Smith Drive/Louisville Drive Traffic Calming

**2021-11-18 Smith & Louisville Dr dwg Markups.pdf**

**SMITH DRIVE/LOUISVILLE DRIVE
 TRAFFIC CALMING**
 Smith Drive Plan Sheet - Louisville Drive to Dayspring Drive

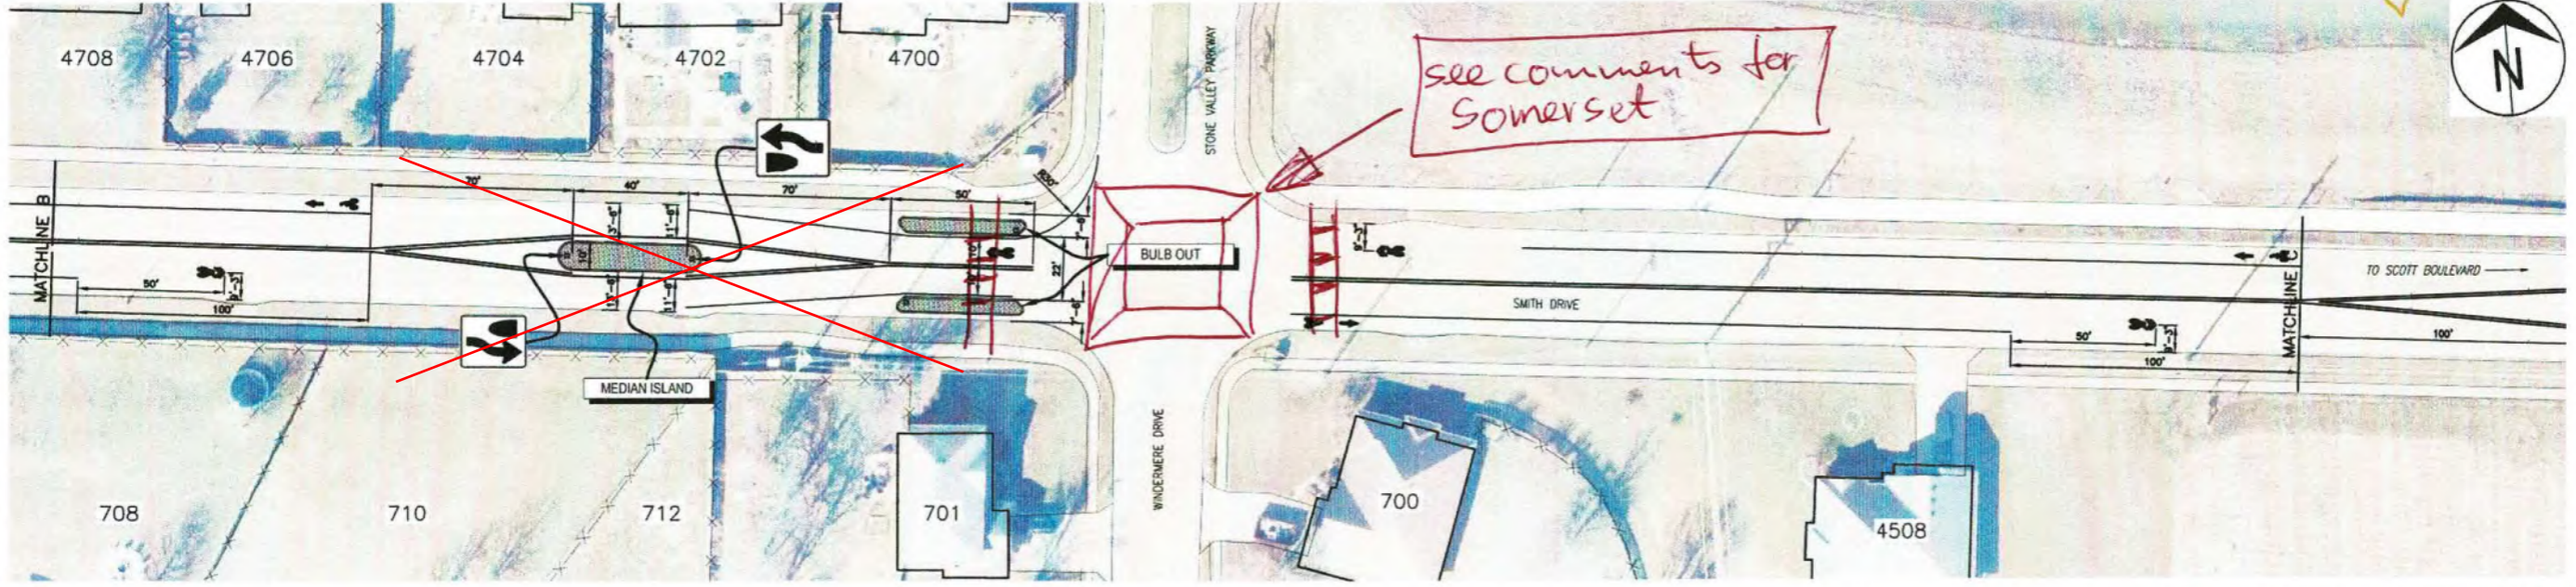
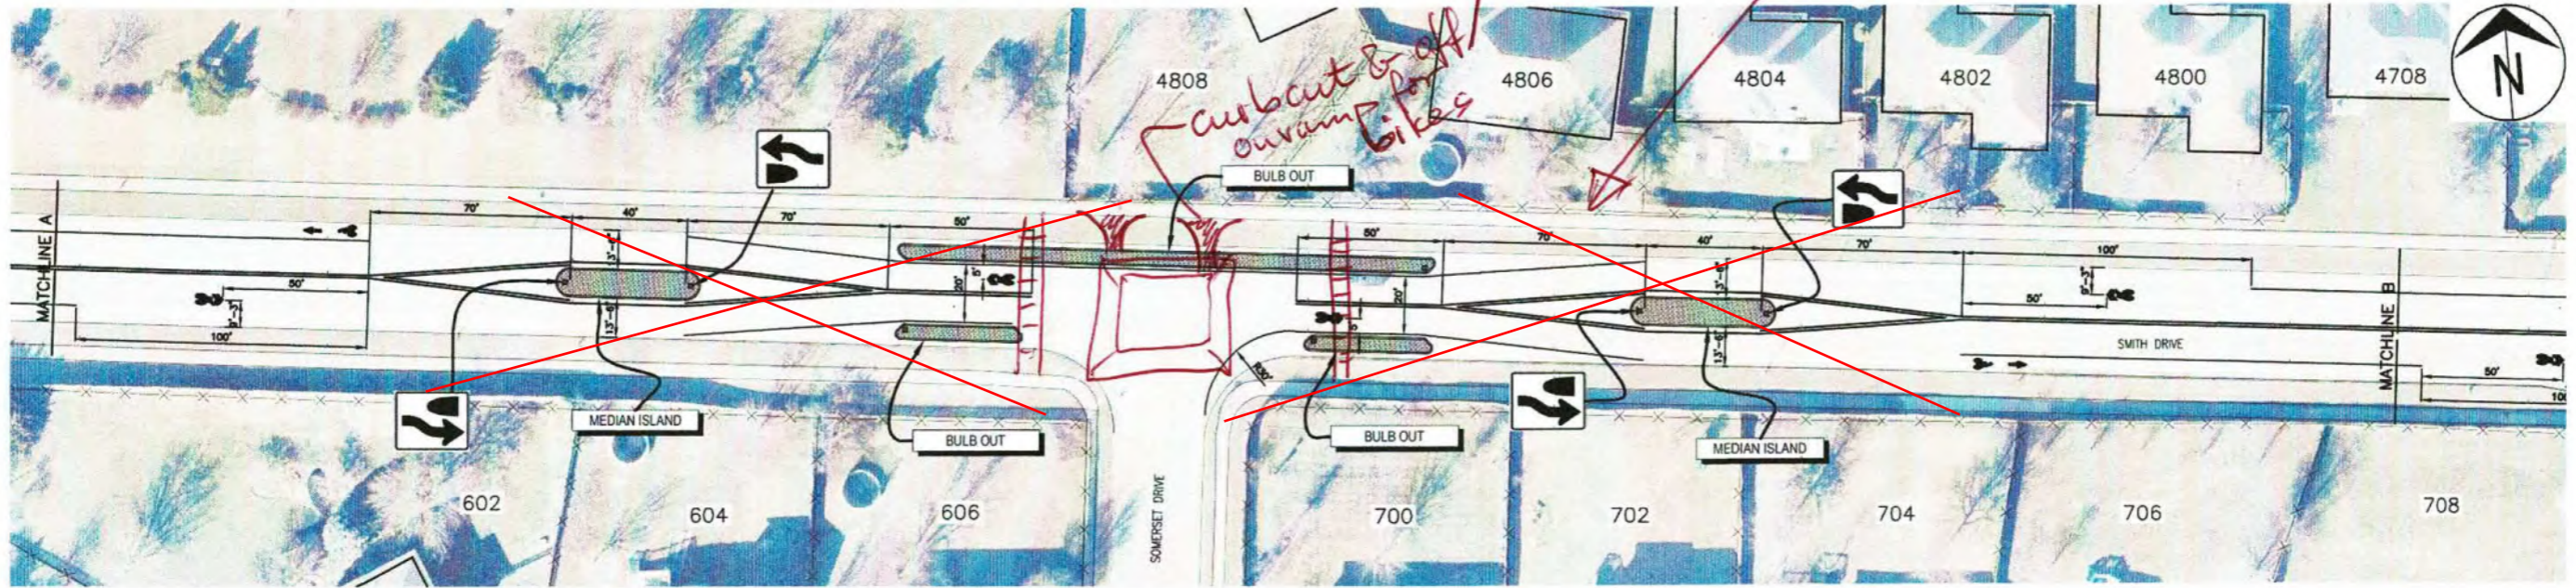
- This design forces bikes into the driving lane. 85% speed is >45mph → unsafe!
 - Makes snow removal difficult
 - Low visibility EB due to vertical curve
 → Add Xwalks on Smith Dr. & Speed Table
 Current design looks dangerous
 - Also provide "off" for bikes to/from Somerset to N Smith Dr. SW

**SMITH DRIVE/LOUISVILLE DRIVE
TRAFFIC CALMING**
Smith Drive Plan Sheet - Dayspring Drive to Scott Boulevard

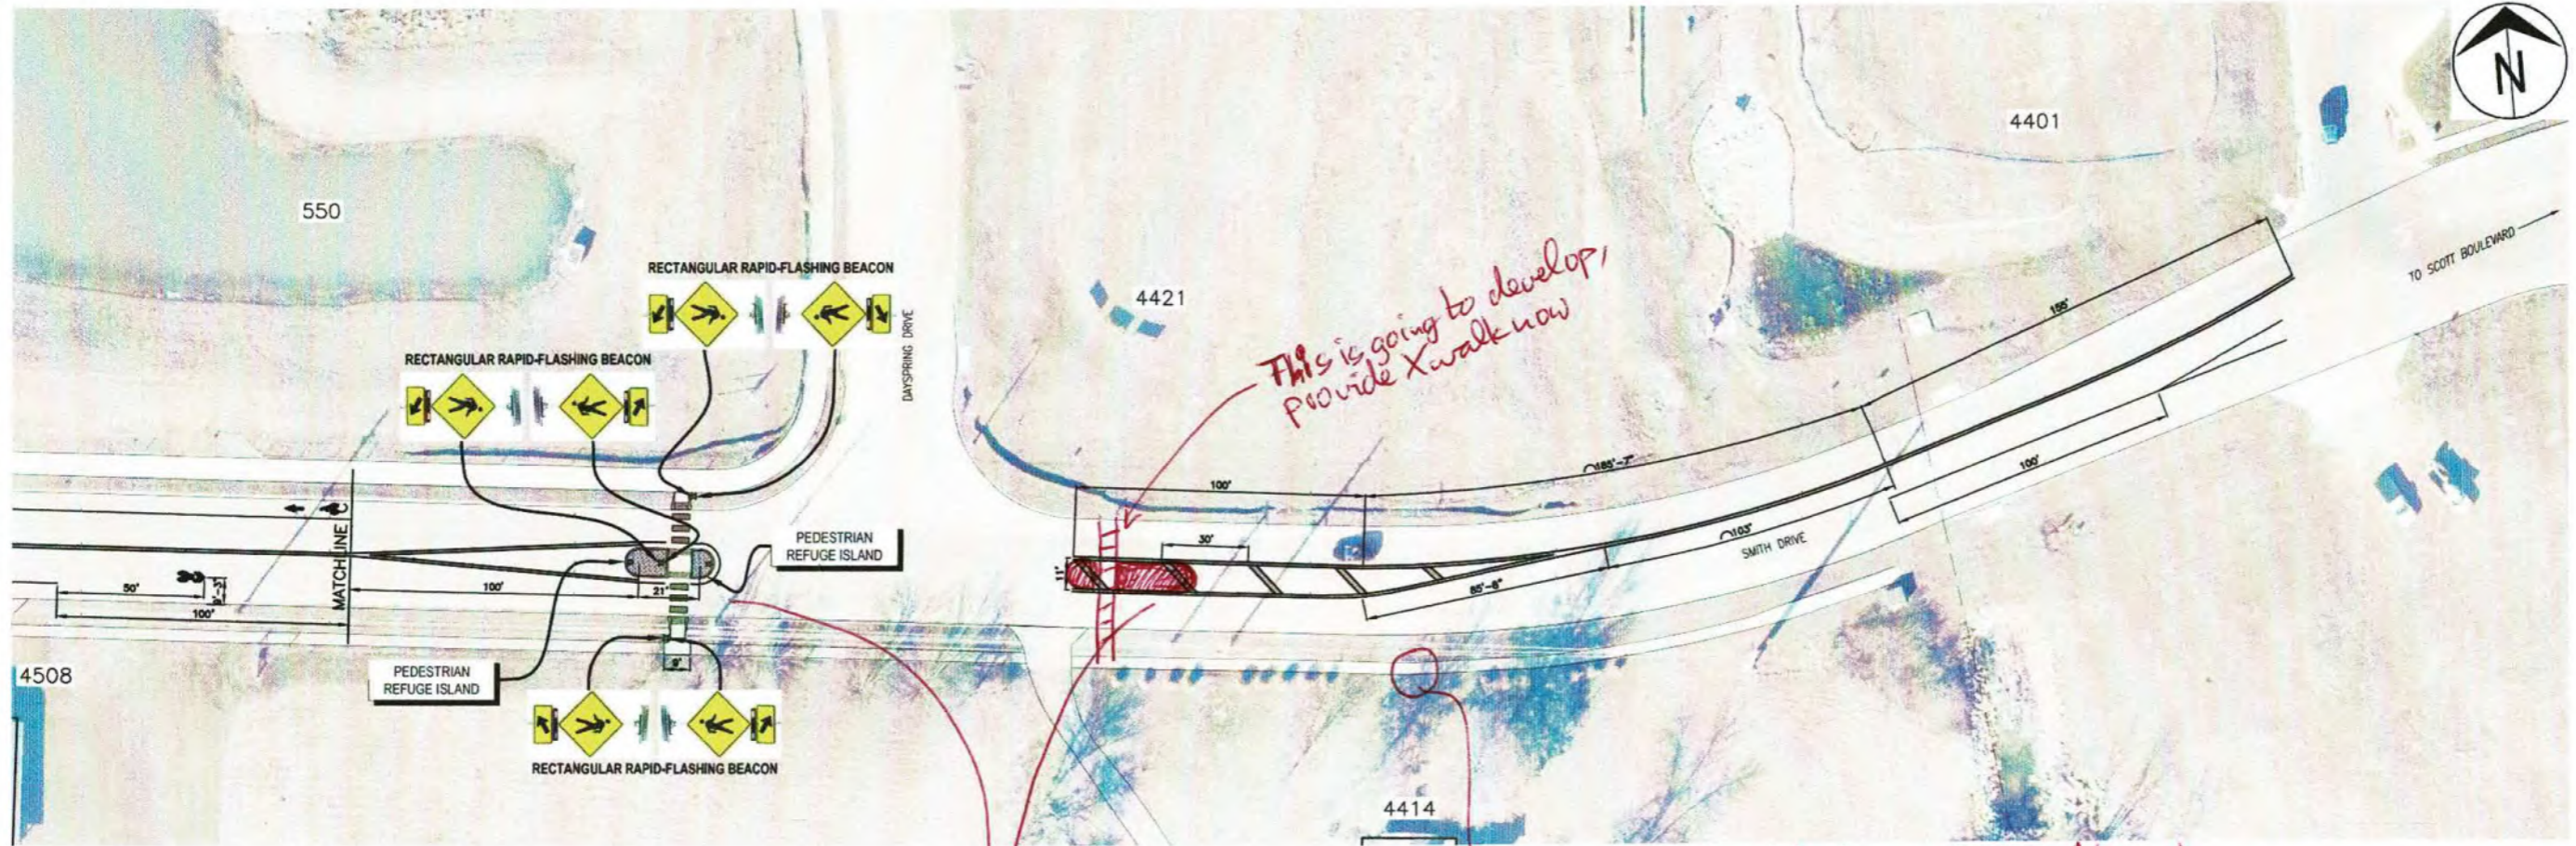
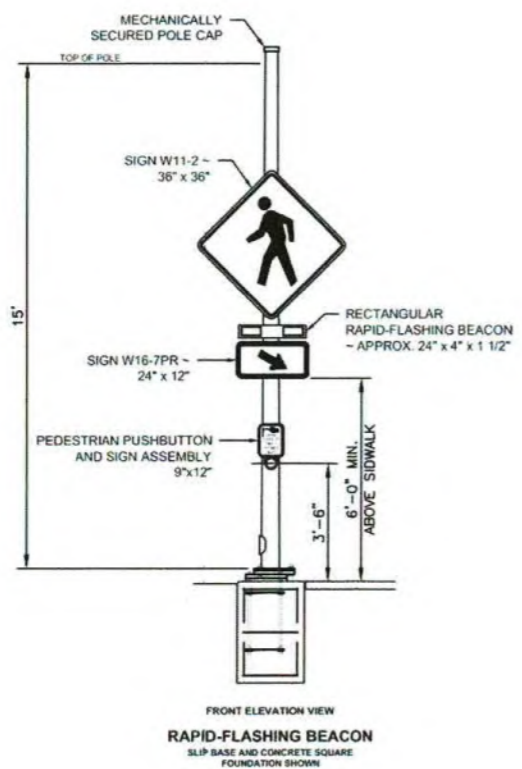
This is going to develop, provide X walk now

consider straightening SW at dead tree stump

Narrow driving lanes as needed to stripe Bike paths to intersection. It is dangerous to merge w/ 45+ mph traffic.

LOUISVILLE DRIVE — RAINBOW TROUT DRIVE
1" = 20'

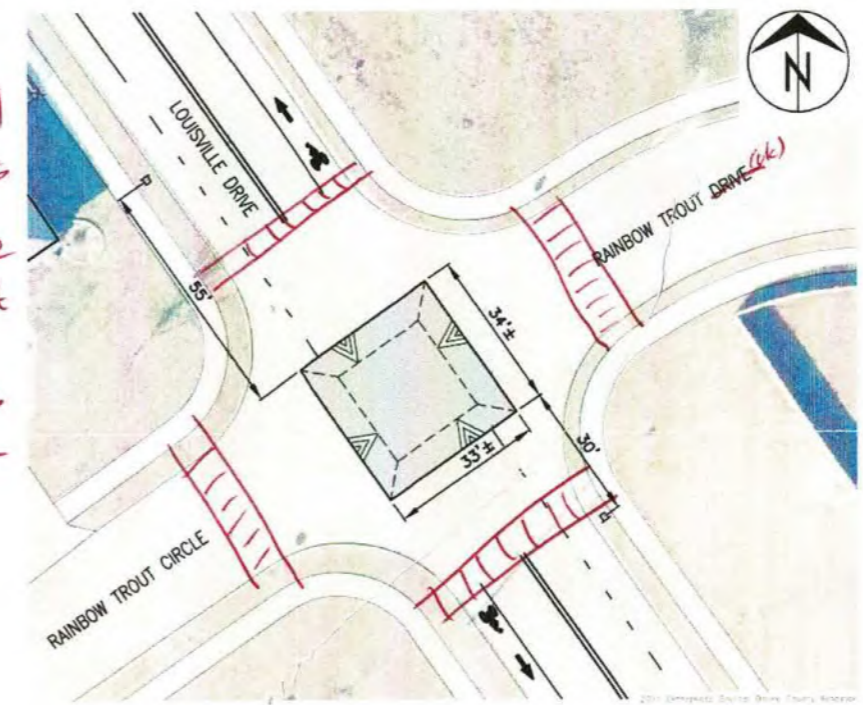
*Add 4
Xwalks
both Louisville
& Rainbow Trout
Dr. ave
cut-throughs
in dense neigh-
borhood*

LOUISVILLE DRIVE — RAINBOW TROUT CIRCLE
1" = 20'

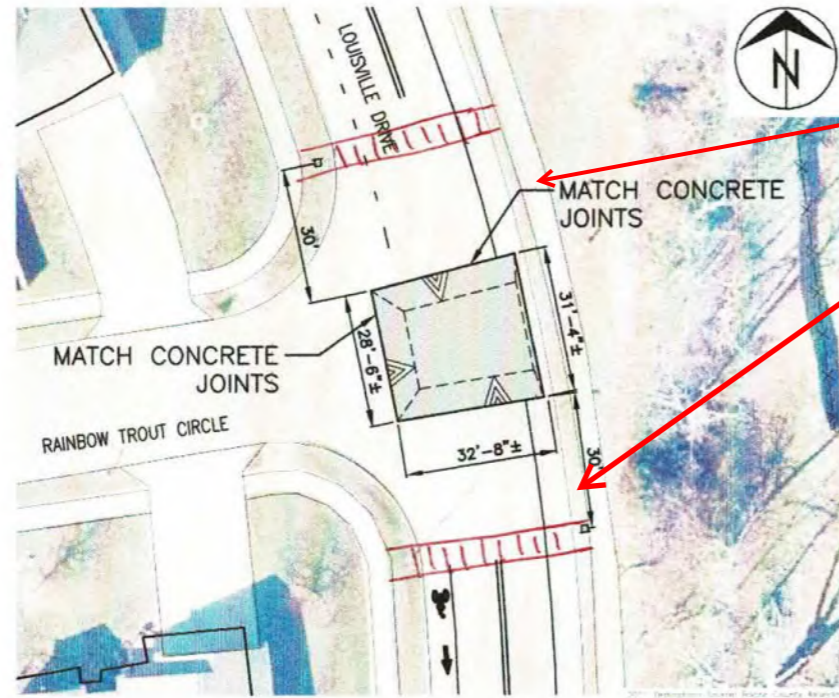
Visibility an issue due to horizontal curve → add Xwalks

LOUISVILLE DRIVE — LABRADOR DRIVE
1" = 20'

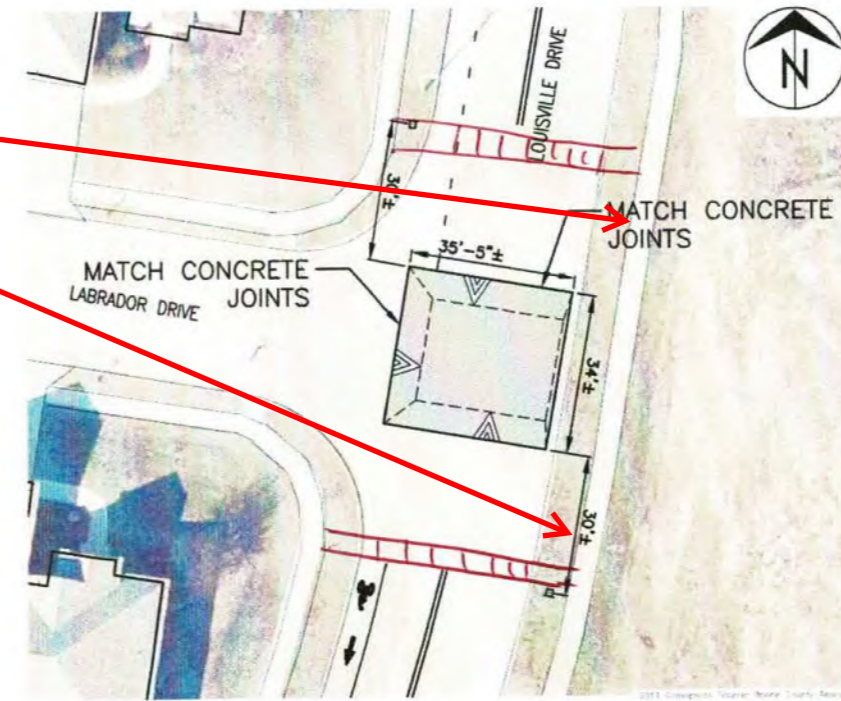
Add bike on/off ramps to SW. Not needed if Xwalks are constructed.

LOUISVILLE DRIVE — TIPTREE COURT
1" = 20'

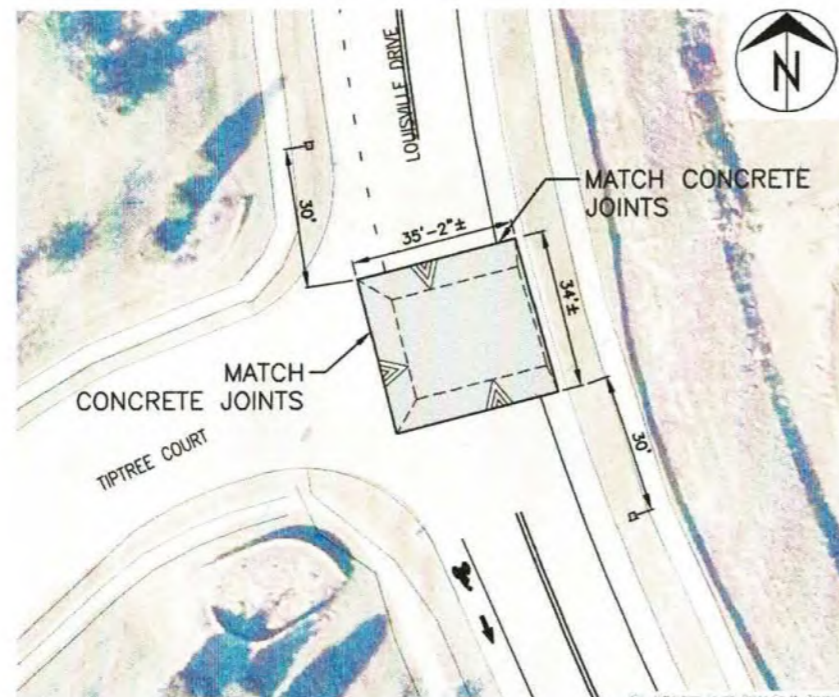
Low visibility due to vertical curve → add Xwalks
